FIELD SERVICE BULLETIN

FSB Number: BJCCFSB2004 - 129
Author: Xu Changhong
Date: 8 Jun 2004
Total No. Of Pages: 3
Subject: **Citizen Polyphonic Speaker Issue**
Model Affected: **EZX A768**
Triplet GSM V300, V303, V500,V600, V400,V525
GSM C650 , GSM V80
Level of Repair: 3

Fig. 2

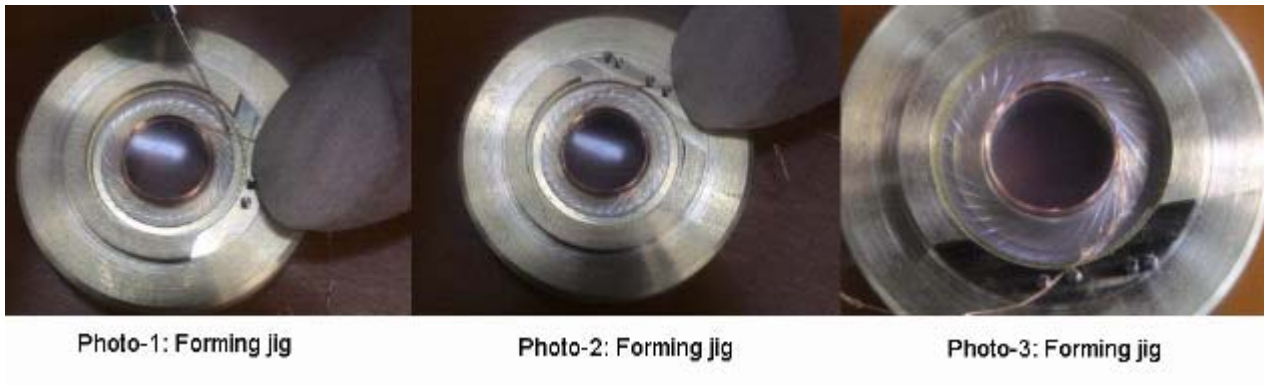
1. Introduce the customized Jig in the coil wire forming process to reduce variation in the forming shape as much as possible (see Fig.2)

Fig. 3

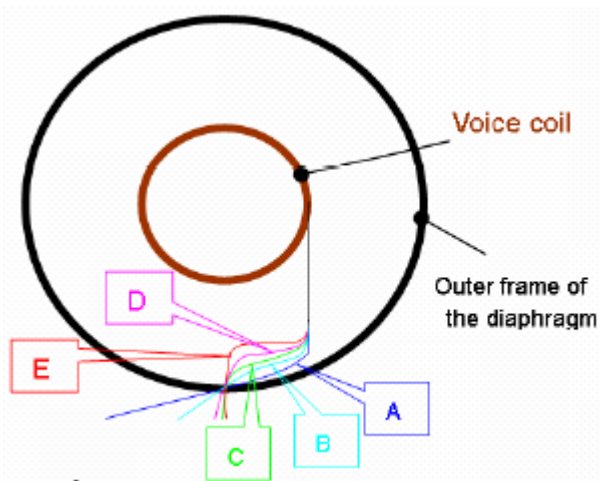
2. Define the boundary sample of corrected coil forming shape as illustrated in Figure 3

The sample B will be accepted as boundary sample of the corrected forming shape.

Fig. 4

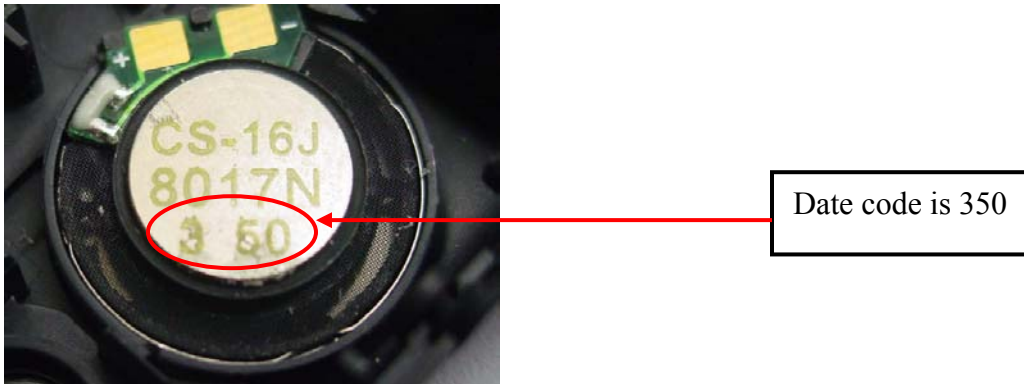
If a phone (A768, C650, V80 and Triplet) is returned to Service Centre for repair with the Customer Complaint of "No ring tone / distorted ring tone" , please first measure if loudspeaker (Citizen) is damaged .If resistance value show open circuit or abnormal, please replace a good loudspeaker with **date code 420 or later**. Figure 4 show how to identify date code of citizen speaker. *If value is normal (8 ohm) , there might be other root cause happened on this phone and please send to Motorola for further analysis.*

Screen existing stock of speaker **(P/N: 5088017N01)** and purge all parts before date code 420.
